Technical Service Bulletin: tsb101255

Released Date: 12-Mar-2003

Intercooler Air Hose, Procedure 010-083

10600218

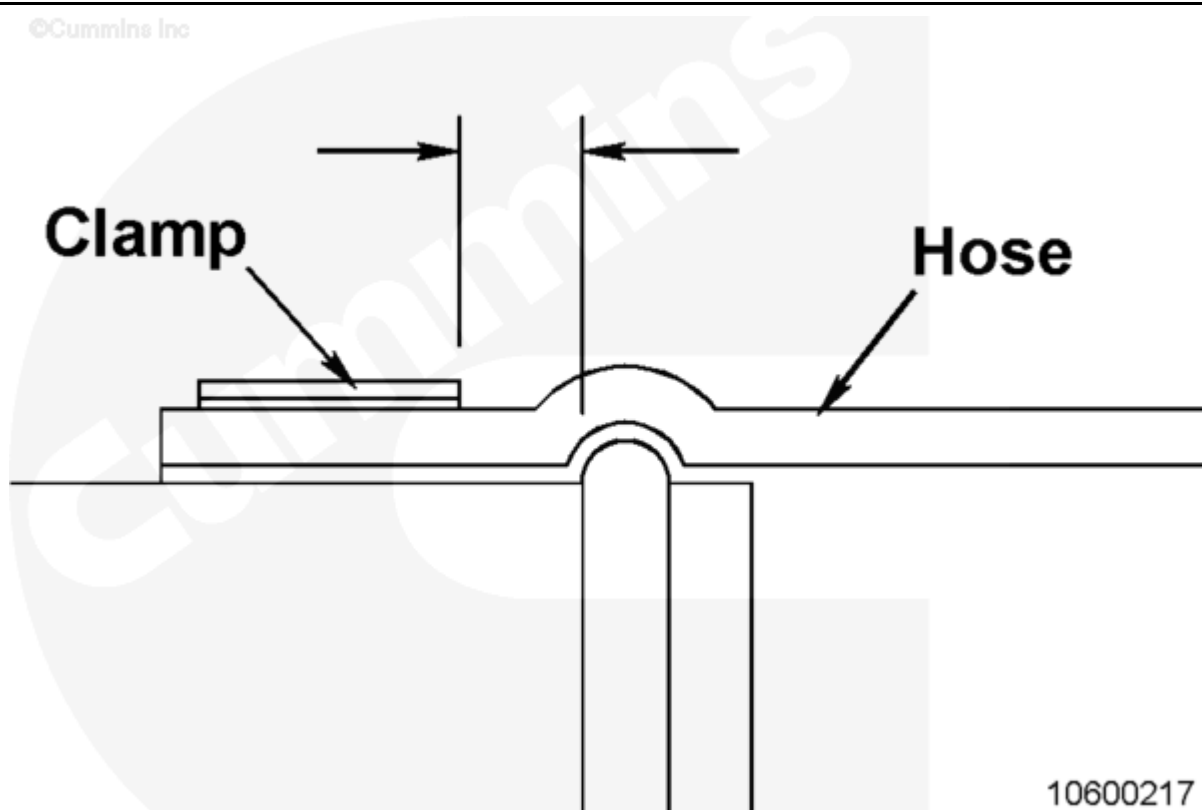
The cross section of the new hose, Part Number 4100590, has been increased to improve durability compared with the old hoses, Part Numbers 3067428 and 3171790. Part Number 4100590 can be used in place of both Part Numbers 3067428 and 3171790. The Daventry engine plant now uses Part Number 4100590 in all six locations.

Part Number 4100590 was introduced in plant with engine serial number first 33152841. The location of the hose is shown below.

The clamps **must** be positioned so the edge of the clamp is between 3 mm [0.125 in] and 6 mm [0.250 in] from the inner edge of the bead, as shown in the drawing above. Clamps **must not** overhang the edge of the hose. **Do not overtighten the clamps. Torque: 9 N·m [80 in-lb]**

This hose contains glass fibers. Installing the hose without first moving the intercooler, or forcing the hose into position will cause damage to the glass fibers and seriously reduce the working life of the hose.
